DRAFT MINUTES
Accessibility Advisory Committee
June 15, 2016
River Plate Room, Town Hall
Meeting No. 6

Facility Accessibility Audit Checklist

Site: Ajax Community Centre Main Entrance; November 26, 2015 (10 am-1 pm)

McLEAN COMMUNITY CENTRE
GROUND FLOOR PLAN

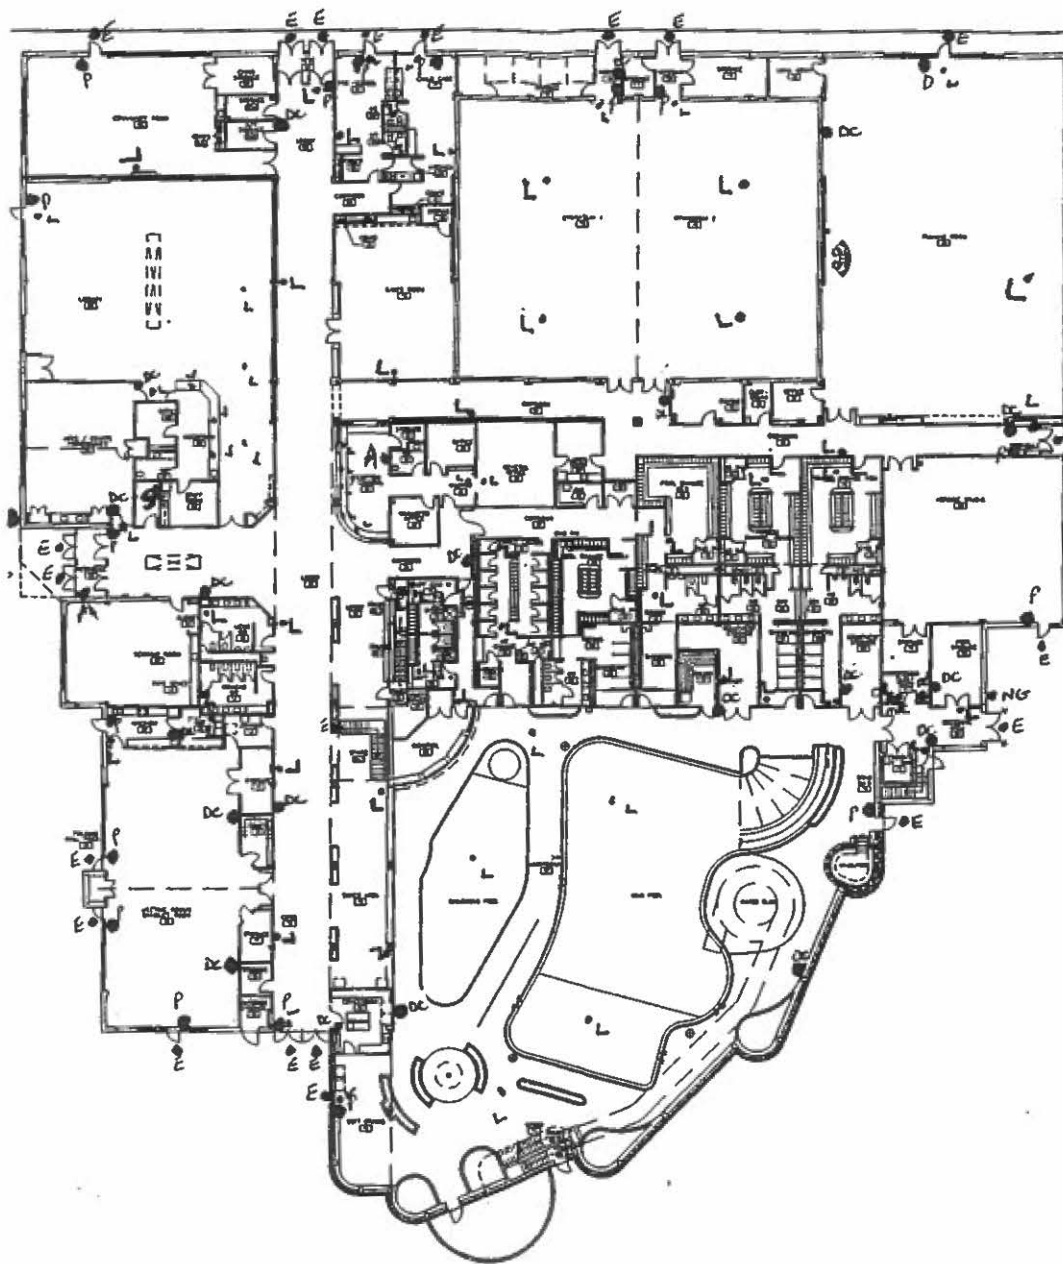
Pool Change Rooms

Benches 12 inches deep – need some deeper ones

Dryers – high

Urinals – 24 inches – needs to be lower

Update all signage

Toilet stalls

Stalls – small

No access to soap

Toilets – 16 inch – raise

Stall Doors need inside handles

Install correct bars

Corner triangular change rooms

need wider doors

bench good – 16.5 deep and 18 high

install a lower hanger

add grab bars

Family Change Room stall -

toilet 17 inches – flush wrong side

not wide enough

door opens in – reverse it

Audley C C

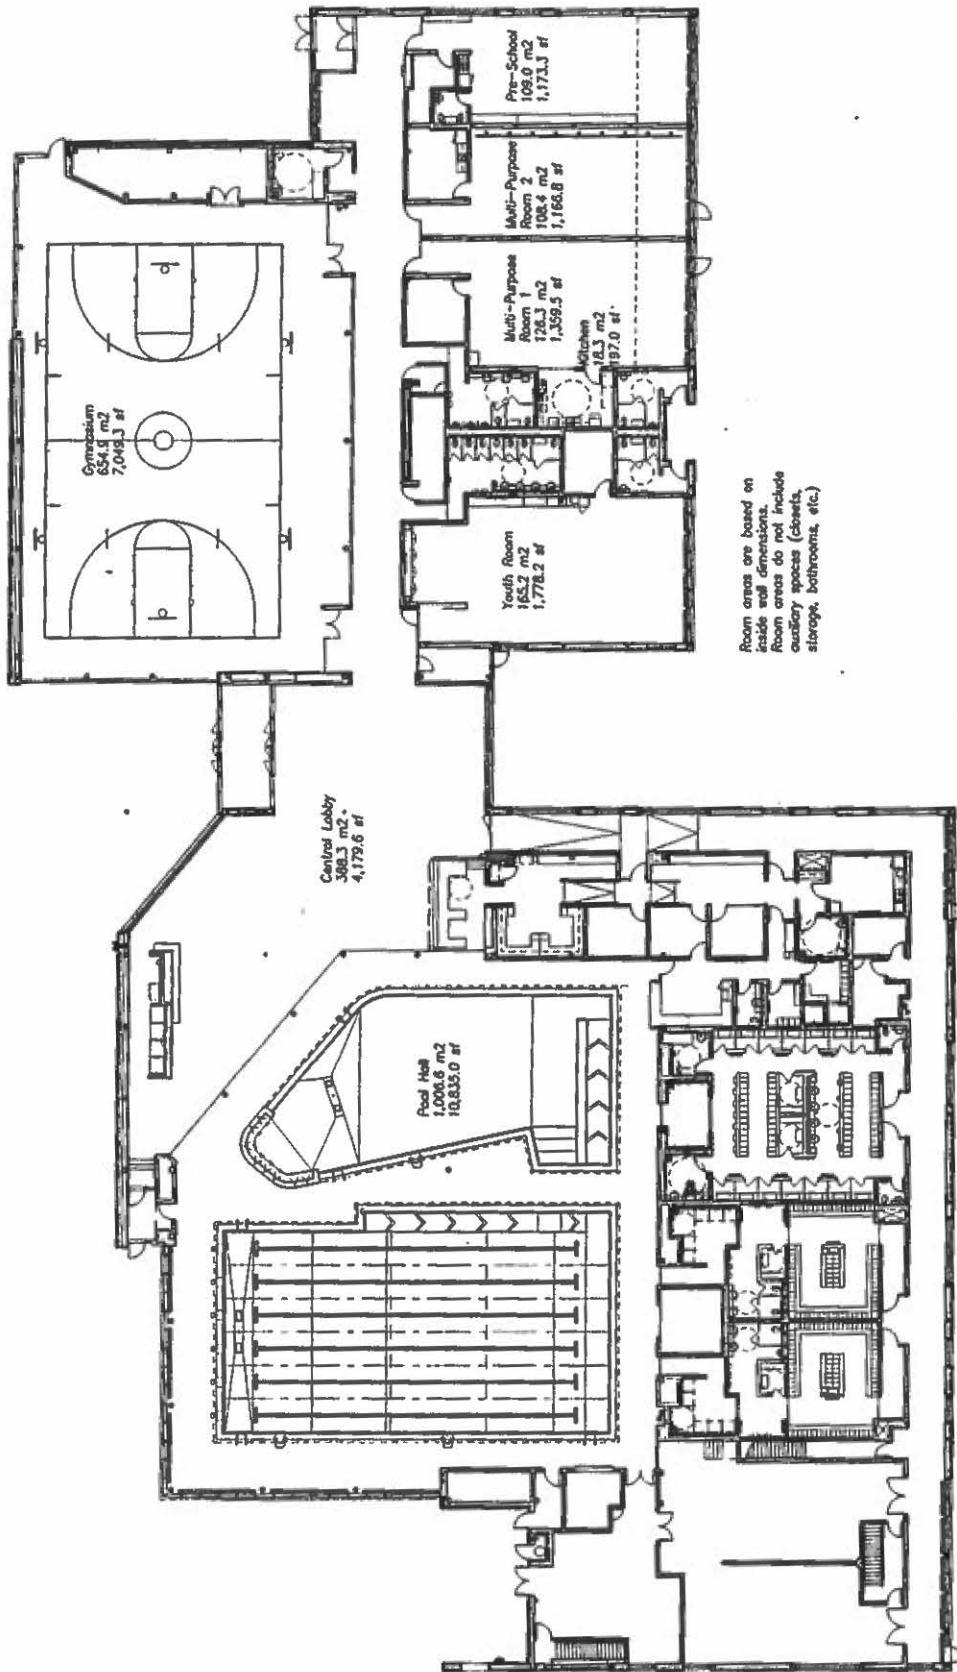
Pool Change Rooms - Some doors swing in – reverse to make accessible.

Main washrooms – excellent.

Many windows and doors need coloured stripes. They are hard to see due to the glare.

Signs all need to be updated. Some are not visible – example on the front of the reception desk.

The Gym and other doors have only 32 inches clearance.

Audley
Hazardous
Broken
Sidewalk.
